**Supplementary Individual Expert Witness Report:
Groundwater Conceptualisation and Quality**

Dr Matthew Currell

NUMBER: EPA495-15

Applicant: NEW ACLAND COAL PTY LTD ACN 081 022 380

Figure 1 – Map showing geological/topographic features (left panel) relevant to interpretation of water level data presented in Figure 2 of Mr Barnett's Memorandum (reproduced on the right panel)

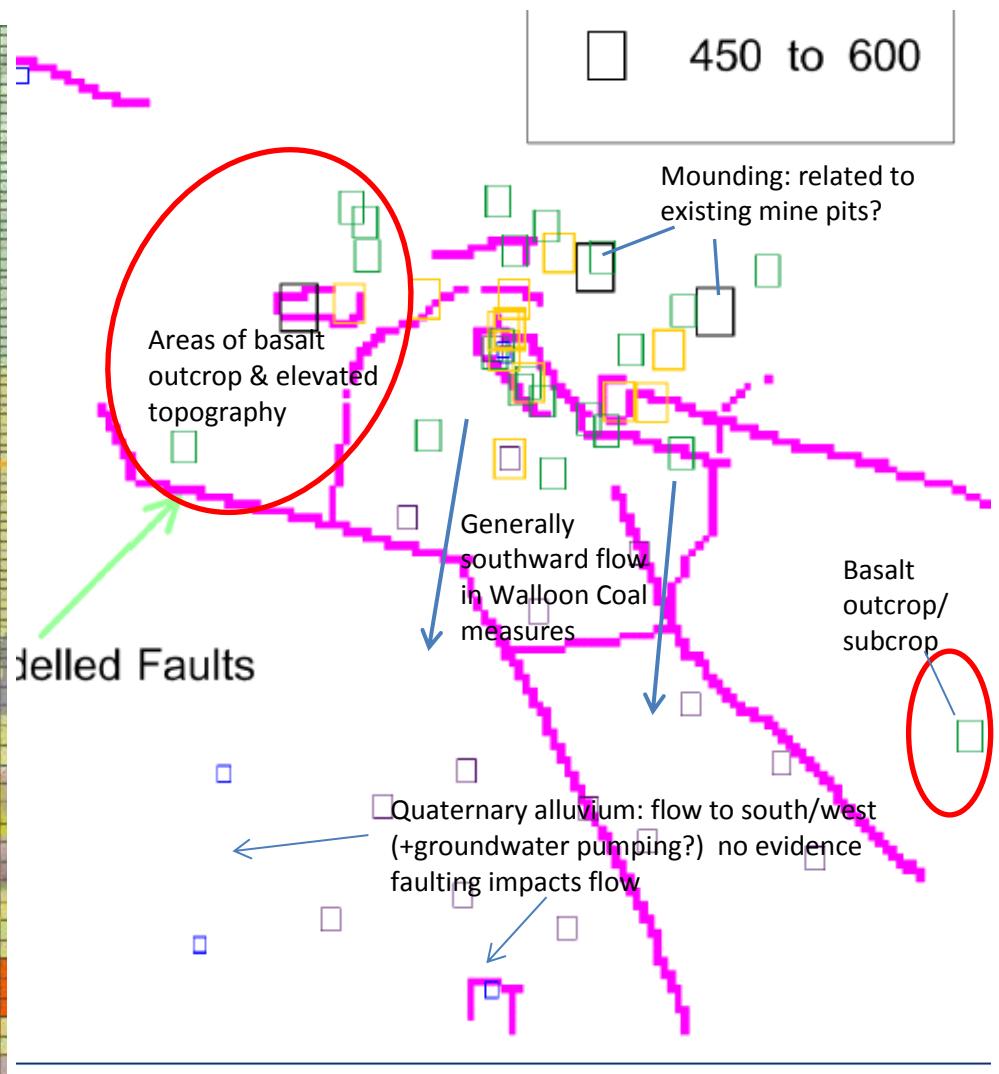
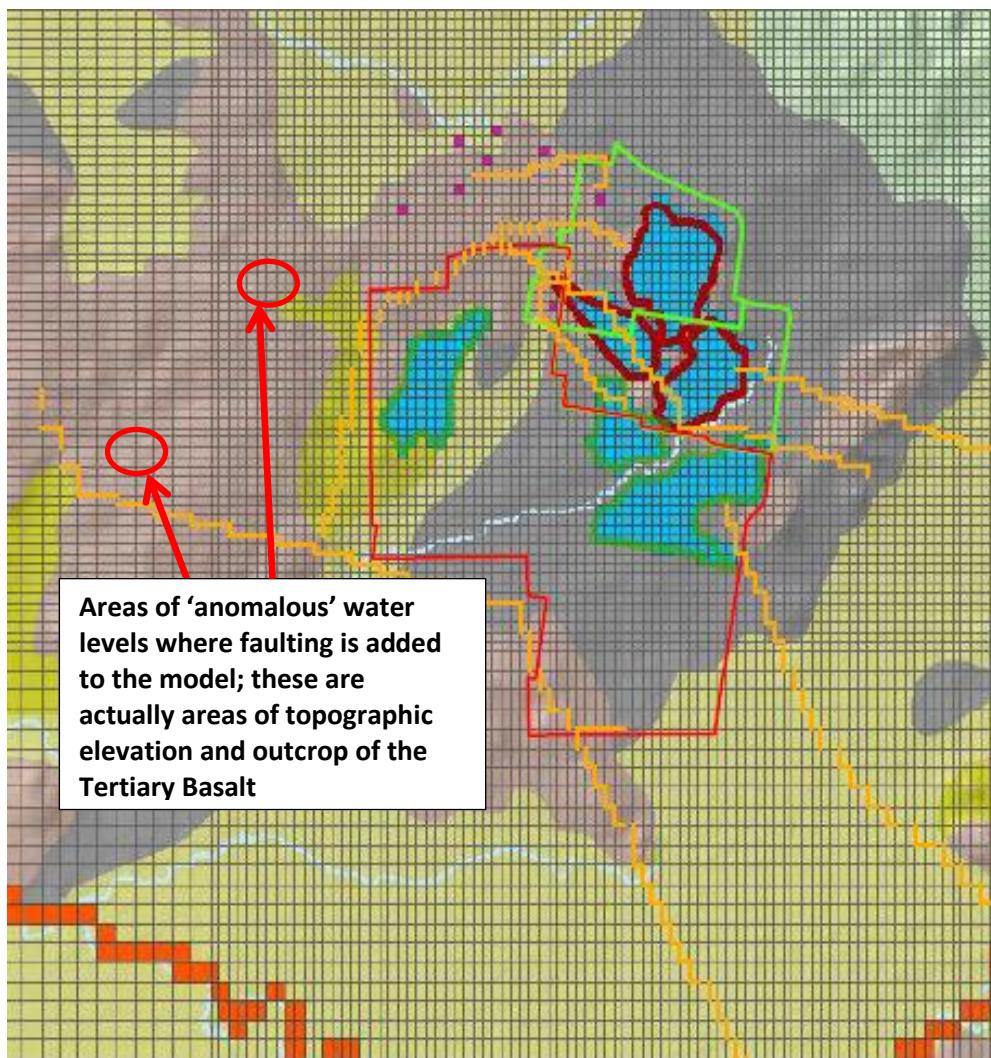
- i) There are major problems with the way water level data has been presented in Figure 2 of the memorandum. For example, it is not clear how many water level measurements were taken at each site and/or when water levels were measured. Water levels at a given site may vary through time, and therefore it is vital that only levels taken on comparable dates are represented, rather than a series of measurements on a single map. Some of the measurements shown may be separated by years, during which significant variability could take place – this is evident in some locations where water level readings with differences of 10s of meters occur at the same location on the map.

- ii) Surface topography and surface geology are not indicated on this map (or on Figure 3 of the memorandum). Topography and geology are critical to the interpretation of water level patterns, and not taking this into account can lead to major errors in the interpretation of water level data. When the water level data are shown in the context of surface geological and topographic data, it becomes clear that these water level measurements cover areas of significant topographic variation, and also changes in the dominant geologic unit occurring at outcrop (see Figure 1 and point 1.5 below). It also is not indicated what depth interval is being accessed by the bores from which the water level data were taken, or even which aquifer. The data appear to be a mixture of bores in the Walloon Coal Measures and Tertiary Basalt, and may also include other aquifer units (e.g. the alluvium). As an example, bore #42231530, which is used as justification for placement of significant faults in the model (Faults #1 and #3 in Figure 3 of the memorandum), appears to be screened in the Tertiary Basalt aquifer (see Attachment B to this report), while the majority of other bores are screened in the Walloon Coal measures. In cases where different aquifers are screened by monitoring bores, separate contour maps of water levels should be created for each aquifer, at which point an assessment can be made as to whether the different aquifers behave as a hydraulically connected hydrostratigraphic unit or not. As a result of these uncertainties, data which appear to be anomalies in water levels in Figure 2 of the memorandum (and which therefore led to the addition of faults to the model) may in fact relate to other factors, including differences in bore depths, lithology, topography and/or geology, and differences in the time period(s) covered by the measurements (see Figure 1 and point 1.5 below). What would be more helpful would be a series of water level contour maps in the relevant aquifer(s), along with side-by-side comparisons between modelled and observed head contours, as was suggested by the IESC in their 2014 advice (this is still yet to be done – refer to Annexure C). Such comparison maps could then be overlaid with the locations of mapped and/or inferred faults, to see whether the inclusion of faulting is consistent with the water level evidence and/or whether alternative conceptualisations might explain the flow patterns.

- iii) Some areas in Figure 2 of the memorandum indicate localised areas where flow patterns are somewhat complicated (although, as noted above, the way these data are presented makes this difficult to assess with confidence). For example, there are areas of relatively high water level within the north of the mine lease and to the west of the lease. However, there are a number of possible explanations (and thus hydrogeological conceptualisations), other than the presence of low hydraulic conductivity fault planes, which could serve as alternative explanations for these observed water levels (see Figure 1 and point 1.5 below). Many influences may control water level patterns in a given area, apart from faulting. These include changes in topography, the presence of zones of preferential recharge and/or groundwater ‘mounding’ (which does appear to be a feature of the site that has not been accounted for); pumping of groundwater in particular areas (note that pumping data has to date never been included in the groundwater model); underlying geological structures such as basement highs or folding, as well as faulting. Such features, or a combination of these, could equally explain the water level patterns observed; as could alternative locations and/or extents for the modelled faults. Due to the non-unique nature of groundwater models, it is possible to achieve calibration using many different possible hydrogeological conceptualisations and sets of aquifer properties; what is thus important is that all aspects of the model ***are consistent with observed evidence from the field***. A series of additional field investigations – such as more detailed evidence on the nature, extent and hydraulic properties of faults; detail about the permeability of surface material and potential zones of enhanced recharge; information about nearby landholder pumping; structural geology such as the nature of any folding, basement highs or local topographic features – as well as further water level data therefore should have been conducted, rather than assigning low hydraulic conductivity faults to areas where these have not been mapped (and conversely, ignoring faults which have been mapped).

- iv) It is stated by Mr Barnett in his memorandum that a number of faults that were not mapped in the field were added to the model “*where they were implied by significant changes in observed groundwater levels over short distances*” (page 14 of the Memorandum). However, the map presented (Figure 2 of the memorandum) is not consistent with this statement. For example, faults were added immediately south and west of bore #42231530, yet this is the only bore within the immediate area - the nearest other water level records are approximately 5km away. Additionally, in this area, water level data only exists on one side of the proposed fault, meaning the effect of the hypothetical fault on down-gradient water levels (to the south) is not clear. Addition of these fault planes is therefore highly speculative and may not be warranted at all. Before faults could be added at these locations, additional water level data (and preferably also geological data) would be required on the other side of the proposed fault, and other possible explanations should be considered. It appears that bore #42231530 and other bores to the northeast (e.g. #42231603) are located in a topographically elevated area where the Tertiary Basalt forms distinct hills in the landscape. It is therefore equally, or perhaps even more likely, that the ‘anomaly’ in water levels in this area, which was used as the basis for adding unmapped faults #1 and #3 (Figure 3 of the memorandum) is actually a function of topography (creating higher groundwater levels in this area) and/or the different outcrop geology.

- v) In some cases, ‘mapped’ faults, such as the two major northwest-southeast trending faults to the south of the mine lease, appear to have little effect on water level patterns (Figure 2 of the memorandum), casting doubt on the conceptualisation of these faults as barriers to groundwater flow. Other problems with respect to these particular faults are:

1.6 While the conceptualisation described above at point 1.5, and presented in Figures 1 and 2 is not considered to be definitive and complete, I have included this to show that alternative conceptualisations also fit the field evidence, and that:

Figure 2 – Map of water levels in Walloon Coal measures as shown in Stage 3 EIS and water level data provided in Mr Barnett's memorandum, indicating areas of groundwater mounding, likely due to enhanced recharge through the existing mine pits.

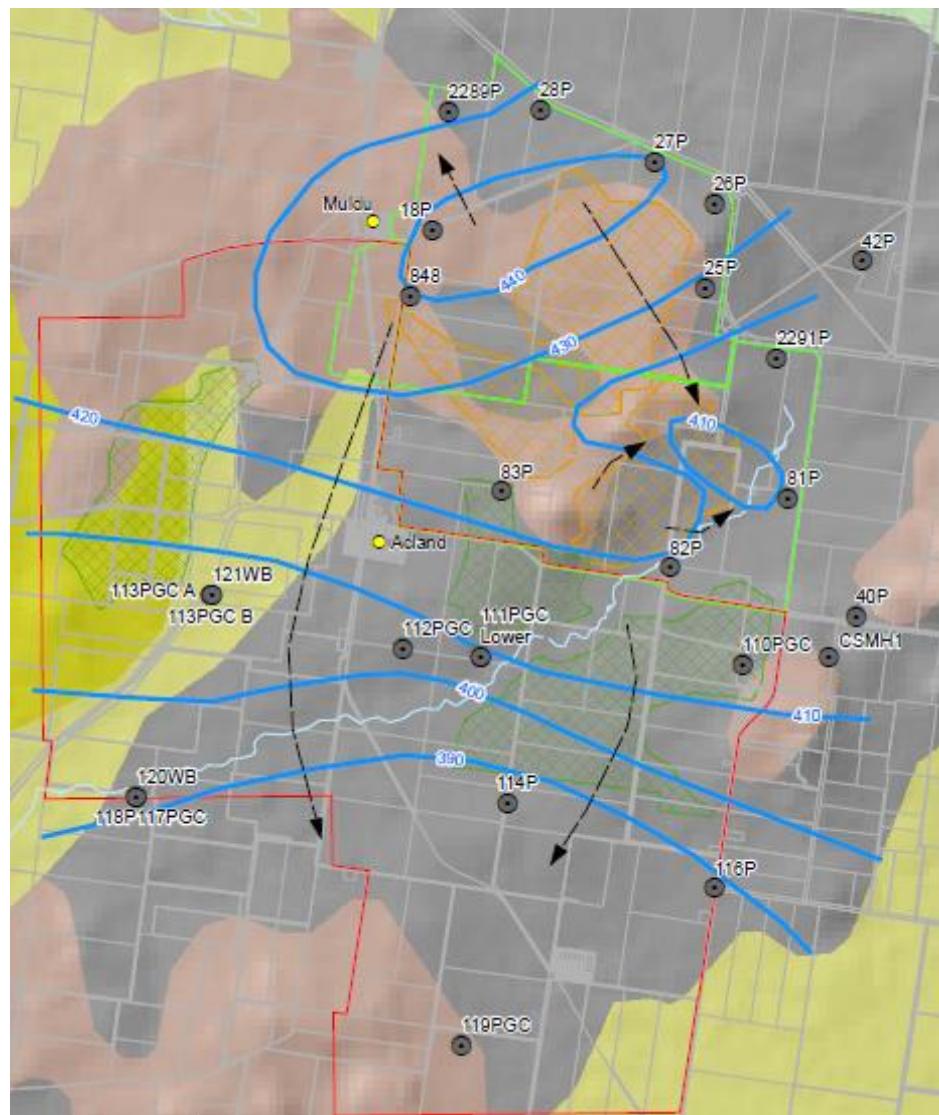
1.5 Alternative interpretations of the geological, topographic and water level data, which could potentially better explain the observed water level data are shown in annotated versions of Figure 2 in Mr Barnett's Memorandum (see Figures 1 & 2, above). This is based on assessment of water levels in conjunction with the mapped geology and topography presented in the EIS (Chapter 6)⁶ and re-review of available bore logs (refer to Annexure B). It can be seen that areas of elevated water levels to the north, west and southeast of the mine lease coincide with areas of outcrop of the Tertiary Basalt and elevated topography (the two are related in this region as the basalt forms local highs in the landscape). If faults (e.g. unmapped Fault #1) were added to the conceptualisation based on an assumption that water levels in bores #42231530 and #42231603 and/or others in the basalt represented the Walloon Coal measures, then the conceptualisation is based on an erroneous assumption, and faulting has been included to explain patterns which could otherwise be attributed to differences in topography and lithology. Within the Walloon Coal Measures, groundwater flow appears to be generally southward, away from the existing mine pits, consistent with the water level map produced using monitoring bores around the mine site in the EIS (see left panel of Figure 2 above). It is noteworthy, that as described in paragraph 4.3 and Figure 3 of my individual report, that the groundwater model does not replicate these observed flow patterns well in the Walloon Coal Measures. Given that water level data presented in Figure 2 of the memorandum appear to represent a mixture of bores in the Walloon Coal measures and Basalts, there in fact appear to be some areas where water levels in the two aquifers are similar (e.g. to the north of the current mine site). This suggests that recharge to the coal measures from the Tertiary Basalt may be occurring, implying that at least locally, there is strong vertical hydraulic connectivity between the two aquifers (currently this is not part of the conceptualisation, see point 1.4(vi) above). This local connectivity is consistent with statements in WSA (2013), e.g., page 10:

Figure 3 – Comparison of observed/modelling water levels in monitoring bores around the mine as of 2013, used as justification for updating the hydrogeological conceptualisation. Reproduced from Chapter 6 of the EIS (Fig 6-23).

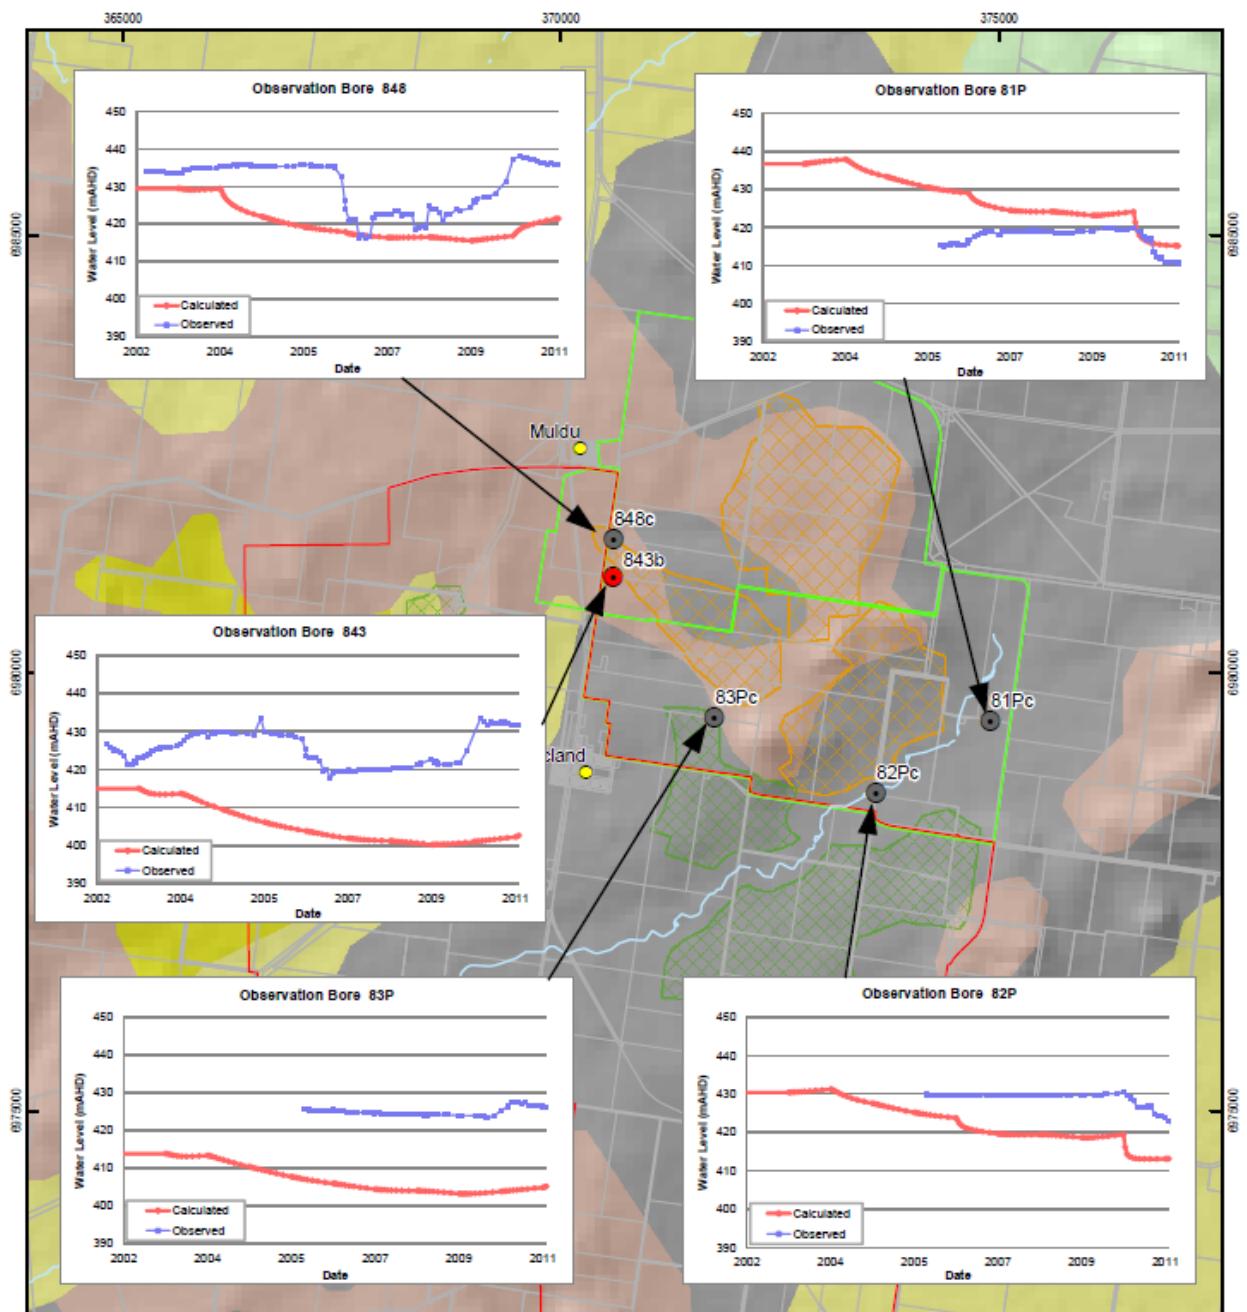
1.8 The ability for the model to replicate observed water levels is still poor, notwithstanding the purported need to include the faults in these locations to improve the model’s ability to replicate water levels. As is shown in Figure 4.3 of the SKM (2013) report and Figure 6-23 of the EIS – reproduced below as Figure 3 - most bores in the Walloon Coal Measures still exhibited modelled water levels 10s of meters different from observed levels, even after modifications to the locations of faults, and some of the hydraulic properties were updated. While some observed water level patterns are matched in model hydrographs produced in the updated modelling (for the AEIS), the overall match between observed and modelled groundwater flow patterns in the Walloon Coal Measures, dictated by head contours, is still generally poor (as shown in Figure 3 of my individual report), and there are other areas where the match is poor in other aquifers also (as was pointed out by the IESC in 2015). This lack of replication of observed water levels by the model reduces confidence in the

hydrogeological conceptualisation, aquifer parameters and model predictions, and means that, in my opinion, additional field data and alternative conceptualisations must be investigated to shore up these aspects.

Figure 5 – Figure 4.2 from the SKM, 2013 report. Note that on the y-axis, 0.1ML/d is equal to 100m³/d

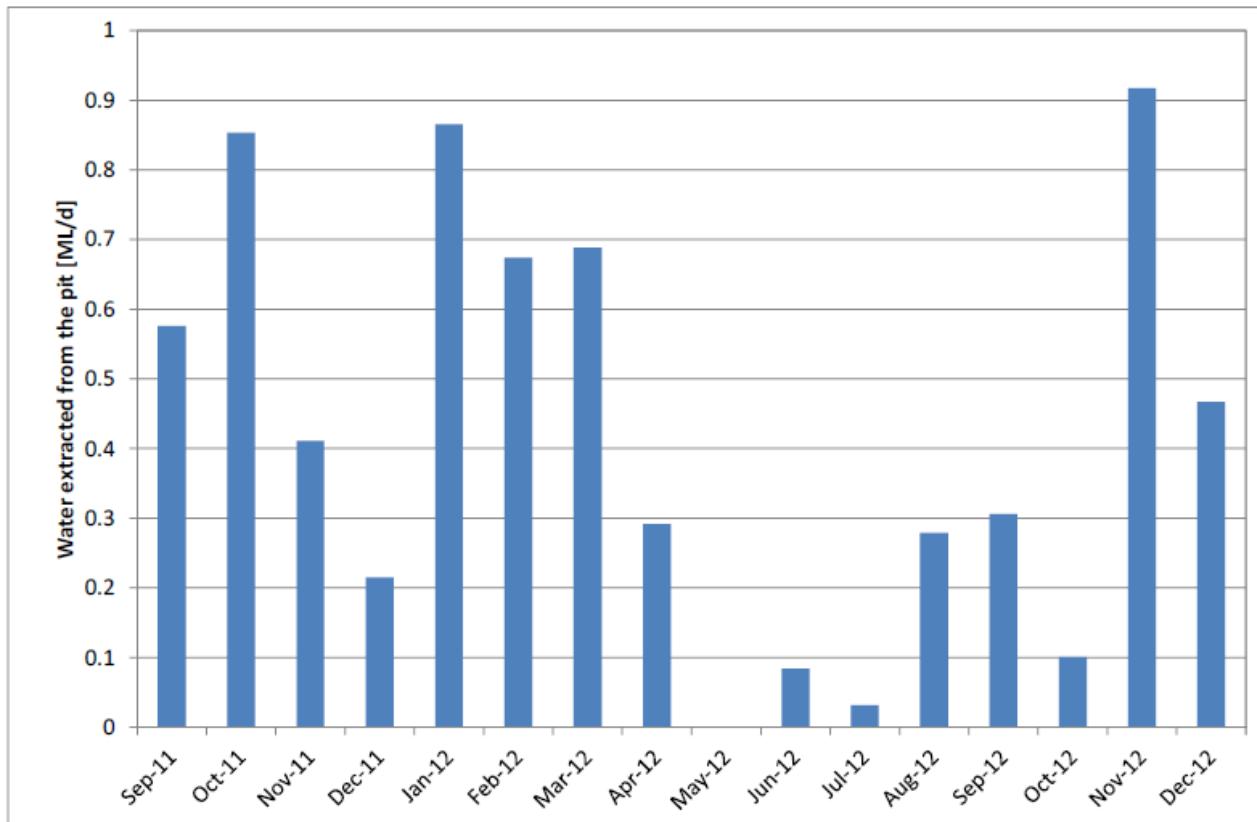
3.2 On inspection of the pit inflows data provided in the SKM, 2013 report, it appears that the values collected in the field are of a highly approximate and imprecise nature. For example, Table 1 from the WSA, 2013 report (Figure 4 below, also reproduced as Figure 4.2 in the

SKM, 2013 report shown in Figure 5 below) indicates that this inflow data actually represents a combination of groundwater inflow captured in the mine pits (ie, true pit inflow) plus any rainfall/surface runoff that accumulated in the pit over the same period. The flows from two separate pits are also summed in the total estimates.
